**Nuclear facilities — Ventilation  
penetrations for shielded enclosures**

**AMENDMENT 1**

Reference number  
ISO 15080:2001/Amd.1:2019(E)

Figure 4

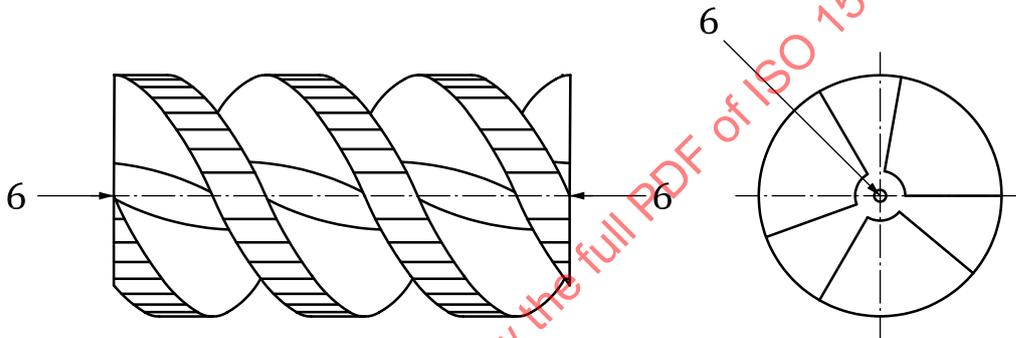
After subtitle a), add the following text:

“In order to avoid deposit of aerosol contamination, the handling screw hole should be filled”.

Subfigure b), replace the figure and the key with the following.

“Key

- 1 pin
- 2 housing
- 3 helix
- 4 flange
- 5 blind nuts
- 6 handling screws”
